**SOAH DOCKET NO. 473-24-18029
PUC DOCKET NO. 56545**

APPLICATION OF ONCOR ELECTRIC	§	BEFORE THE
DELIVERY COMPANY LLC FOR	§	PUBLIC UTILITY COMMISSION
APPROVAL OF A SYSTEM	§	OF TEXAS
RESILIENCY PLAN	§

**RESPONSE OF ONCOR ELECTRIC DELIVERY COMPANY LLC
TO COMMISSION STAFF'S
FOURTH REQUEST FOR INFORMATION**

RFI Response Figure A: Burn Probability (Likelihood of Wildfire Occurrence) – Oncor Transmission Information System (OTIS) Wildfire Risk Module (underlying GIS dataset is a spatial dataset from United States Forest Service, clipped at Oncor Service Territory)

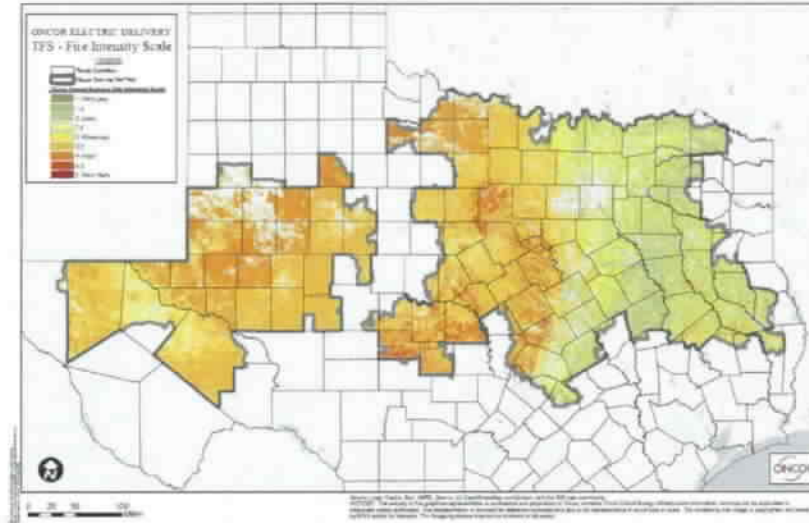
Please refer to Table 8 on page 60 of the Oncor System Resiliency Plan (bates page 79). For Program C: Asset Protection, the plan estimated scope includes 17,574 Pole wraps, 45 Substations/21 Telecom Towers/1,330 Critical Poles defensible spaces, and 12 Wood Substation rebuilds. Please provide maps demonstrating that these assets listed above are in elevated wildfire probability and fire intensity areas or any other documentation used in identifying these assets for Program C: Asset Protection. Regarding the defensible spaces listed in Activity 2, please describe the area (ft²) and the improvements proposed within this area, for each of the three asset classes identified (Substations, Telecom Towers, and Critical Poles).

Under Oncor's current risk modeling tool used to determine Wildfire Mitigation Zones ("WMZs"), burn probability (i.e., likelihood of ignition), fire intensity, and susceptibility are considered the fundamental components for quantifying wildfire risk. Burn probability depicts the annual probability of wildfire occurrence at each specific location, based on historical wildfire events and weather patterns (please see RFI Response Figure A below, not contained in the SRP), while fire intensity identifies areas where significant wildfire fuels, topography hazards, and historical weather associated with dangerous fire behavior potential exist (please see RFI Response Figure B below, not contained in the SRP). Susceptibility is modeled by combining the community protection zones (as defined by Texas A&M Forest Service) and critical infrastructure zones (which reflect critical natural gas facilities served by Oncor, as defined by the PUCT).
